**THE LOUISVILLE-SOUTHERN INDIANA OHIO RIVER BRIDGES PROJECT
SECTION 2, DOWNTOWN BRIDGE**

**KENNEDY INTERCHANGE AND DOWNTOWN INDIANA
AREA ADVISORY TEAM DESIGN WORKSHOP
THE 300 SPRING BUILDING
300 SPRING STREET, JEFFERSONVILLE, IN
MARCH 27, 2008
6:00 - 8:00 PM**

SUBJECT: Three Tower Cable-Stayed Downtown Bridge Workshop – *Round Three*

March 27, 2008 Area Advisory Team Meeting Summary

*Option 1:
Preferred Alternative*

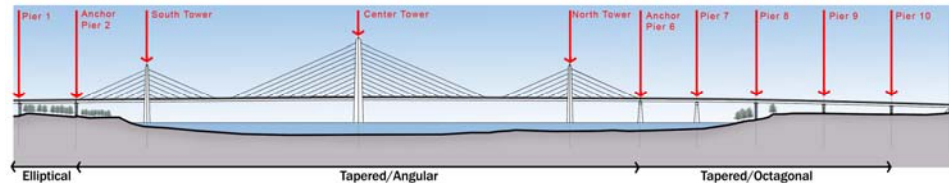
AAT Meeting 2: Comments

- Do not cover up
- Do not provide underside covering
- Prevent bird roosting
- Keep simple and clean
- Embrace natural structure

- Do not decorate
- Keep simple
- Use angular treatment consistent with tower

- Arched pier cap breaks up straight line effect
- Straight pier cap is more consistent and compatible with tapered tower

- Avoid too much light
- Noise should be considered
- Color should be compatible with Kennedy Bridge
- Keep simple and honest

- Tapered/Angular Towers and Piers
- Arched pier cap and tower cross strut
- Slanted cheekwall at bridge/approach interface
- Treatment below structure to remain simple and “honest”
